Equipment affected : Tandem Drogue chute bridle P/N: P2007022810 / P1007022810.

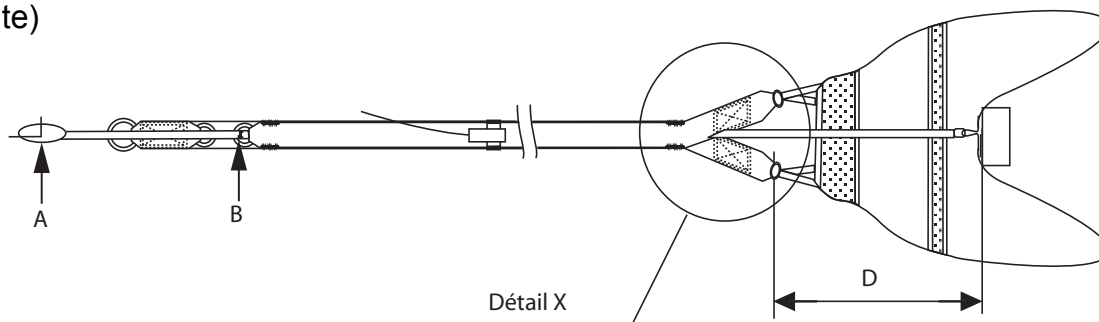
- Strong snatch force after drogue chute assembly release.
- Acceleration of the TANDEM after a drogue chute assembly release due to deployment delay.

- A mix of different generation components.
- Differential ageing of the various subpart materials.

- Hard snatch force effect spreading at beginning of deployment sequence (not enough collapsing of drogue chute).
- A delay during the opening sequence (too much collapsing, poor drag of drogue chute).

- 1- Anchor the lower end of the deflating inner bridle at the point **A**.
- 2- Pull the external white bridle to reach the stop at point **B**. (maximum collapsing of drogue chute)

- 3- Measure the length « **D** » as indicated on the drawing above.

WARNING : Whatever the configuration of drogue chute + drogue chute bridle assembly, the measurement of the dimension starts from the end of external bridle to the handle base.

CORRECT CONFIGURATION : $D = 27 \text{ cm} \pm 5 \text{ cm}$.

- Adjustment of the Bartack sewings location (unpick & re-stitch).
- Adjustment of the inner bridle (too long bridle: unpick & adjust the ending loop of inner bridle on drogue chute side).
- Replacement of the internal bridle (too short bridle). In that case, please contact Parachutes de France After Sales Service.

Detail X

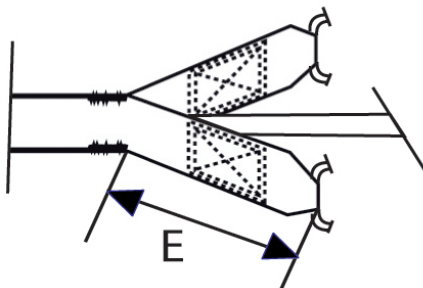
- 4- Check the length « **E** » from the Bartack sewings to the top of the bridle.

$E = 28 \text{ cm} \pm 1.5 \text{ cm}$.
